ADDENDUM NO. 3

Notice to All Persons and Firms Proposing
to Submit a Bid or Furnish Materials for
Musick Avenue Bridge No. 412
St. Louis County Project No. CR-1452
Federal Project No. BRM-5572(602)

I:\StLouisCoH-T\80330\Cadd\Civil\Sheet\003 Detailed Quantities Sheet.dgn 4/13/2017 2:30:10 PM amsmith2

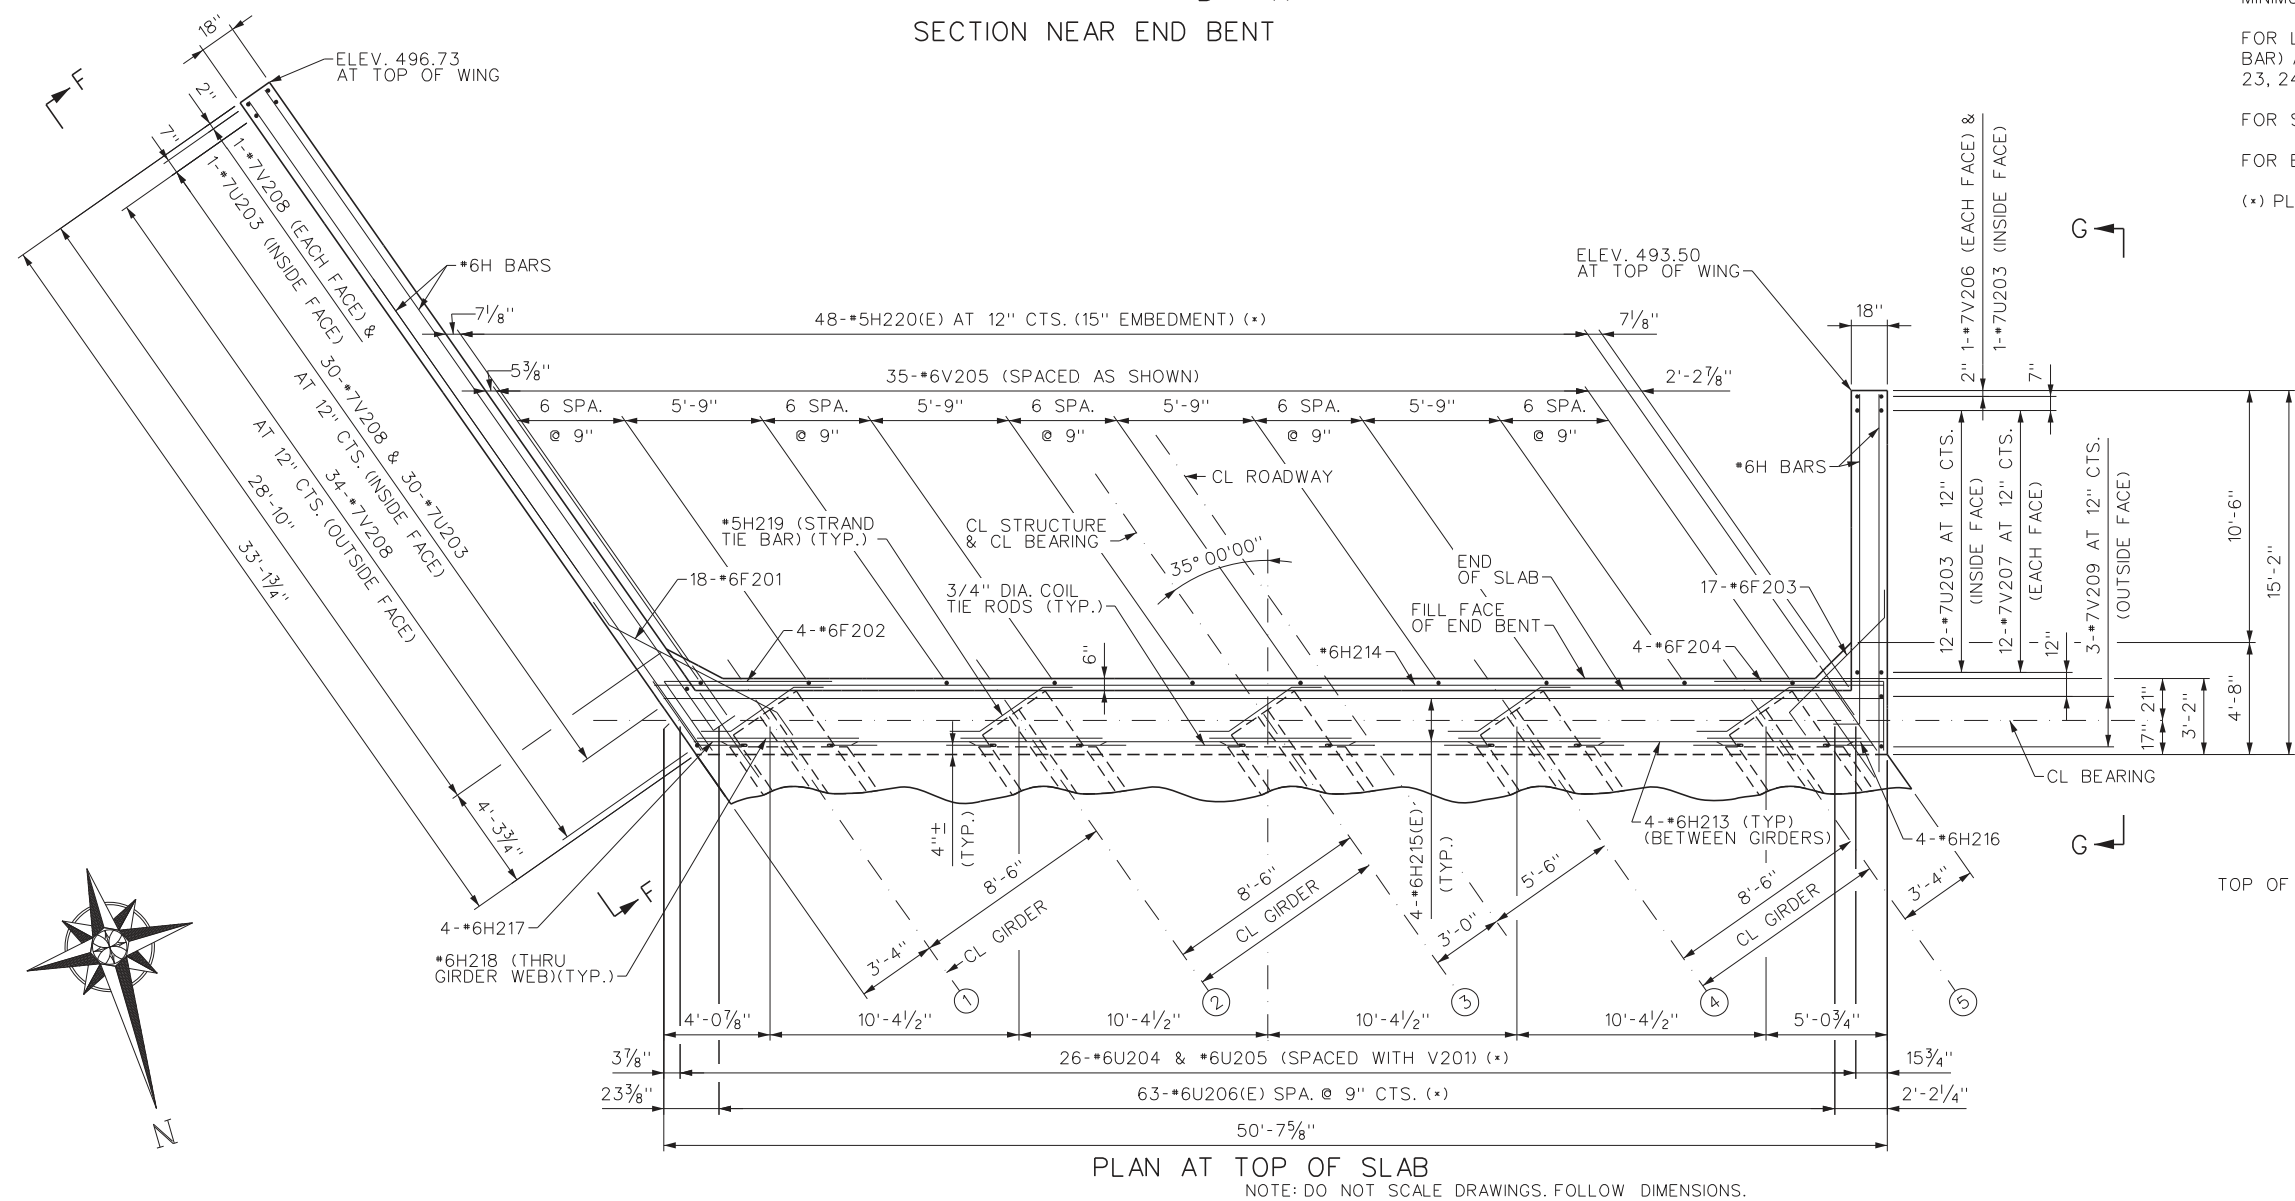
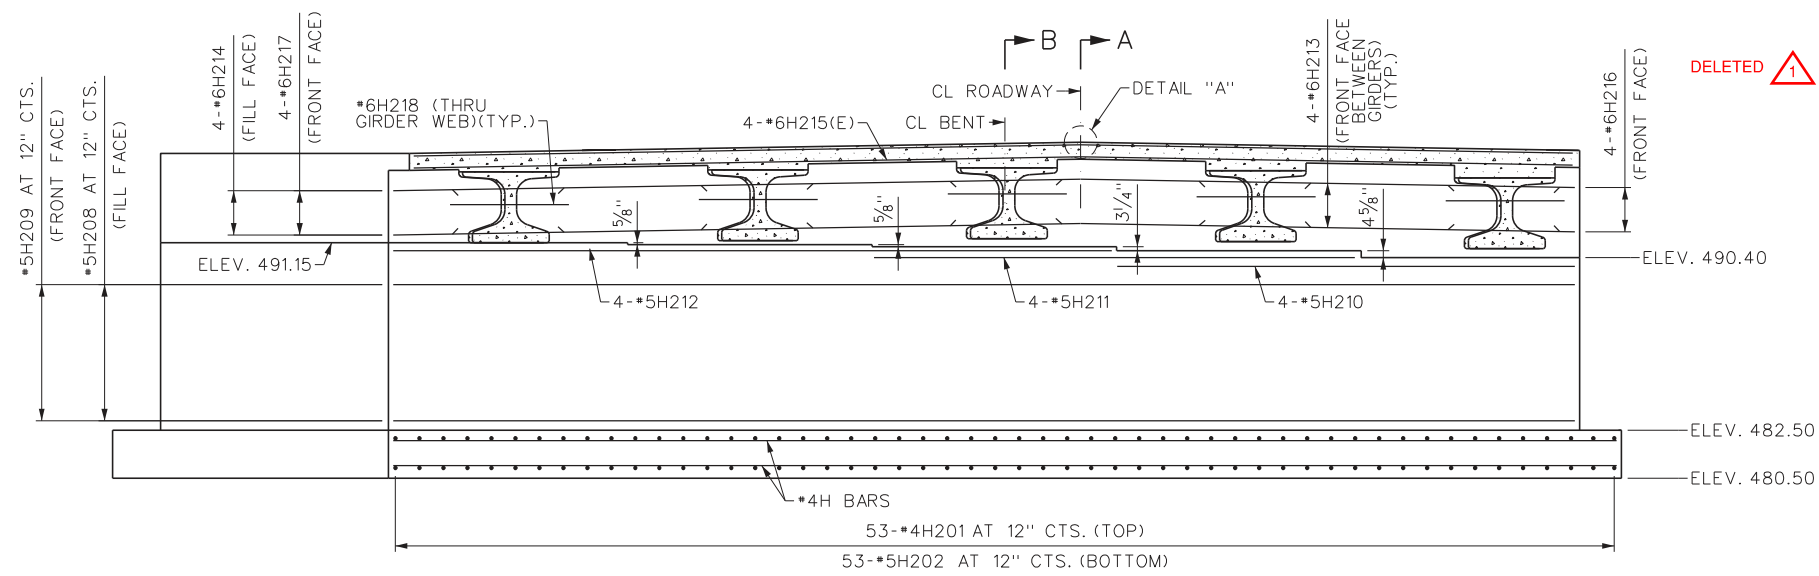
No. 2

Revised Detailed Quantities, Sheet 3 of 53 in construction plan set as follows:

Replaced pay items as follows:

Remove Items: 603-10.90 Expose Water Service House Leads (2" or greater)
603-20.35 Relocating Water Service Connections (2" or greater)

Add Items: 603-10.09 Expose Water Service House Leads (Less than 2")
603-10.10 Relocating Water Service House Leads
